The Fitzroy Park Residents' Association

29 July 2017

RE: 2017/3426/P – 53 FITZROY PARK, LONDON N6

By means of this letter and the associated supporting documents as listed below, the Fitzroy Park Residents' Association wishes to object formally to the above Planning Application.

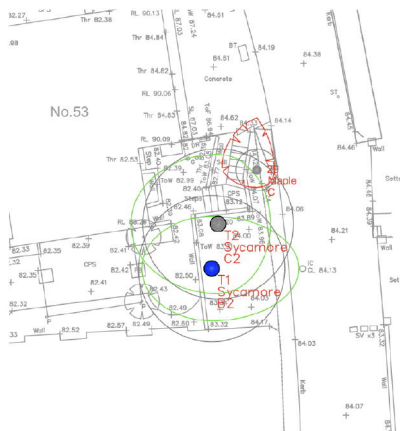
- ii) The retaining wall shown at right angles to the road boundary “to be strengthened to support road” does not exist as drawn. so the road, or the newly enlarged loading platform above, can be supported as stated,

- 2.4. The physical topography of the site slopes from the road to the main site levels 4m lower by approximately 30 degrees, yet no assessment has been made, or details provided, of exactly how the road edge will be strengthened to protect it from subsiding (particularly now the critical retaining wall does not exist) or how operatives will safely access welfare and other services down that slope.

Plan Extract 1: Phase 1 Loading Platform (Plan Ref: KB53FP-LOG-001)

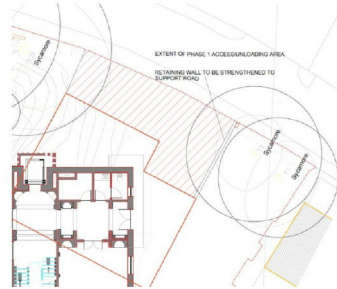
- 3.12. AIA survey drawing (below) shows T2 trunk inches from proposed loading platform with wooden steps, not a retaining wall that does not exist.

- 3.13. AIM narrative and drawings rely on vital retaining wall that does not exist. As mentioned above, the AIM gives no indication of how existing ground levels will be raised 2.2m to existing drive level and how this might impact RPAs.
- 3.14. Annotation of T2 in the AIM (and in the CMP) is grossly misleading as neither shows the actual proximity of this retained tree to the edge of the proposed loading platform, or its relationship with the existing split ground levels.

3.15. AIA narrative also wrongly suggests RPAs restricted in terrace bed that does not exist as drawn.

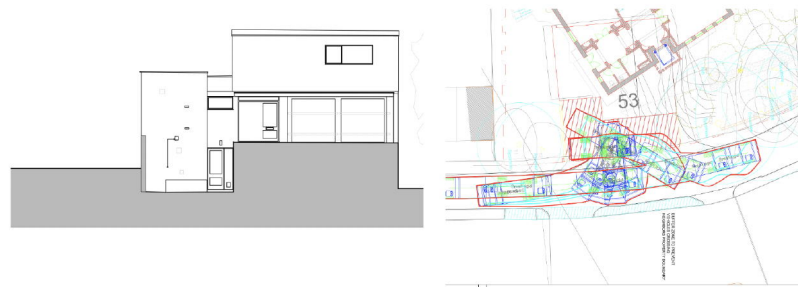
- 4.18. The loading platform is not representative of actual conditions on site. For example, during Phase 1 the side dog-leg will need to be built up by 2.2m leaving only a very small front driveway for all loading/deliveries.
- 4.19. Screen shot of architects drawing below shows the existing drive level to the right and 2.2m drop to the left where the critical dog-leg extension is proposed to facilitate a space for HGVs to reverse into to leave (as shown by their SWA) but no mention that the platform is in actuality split-level. Shaded wall drawn to the left is only a short stub wall extending from existing building by circa 2m. As previous photos show it does not exist as drawn on Applicant's CMP and AIM drawings.
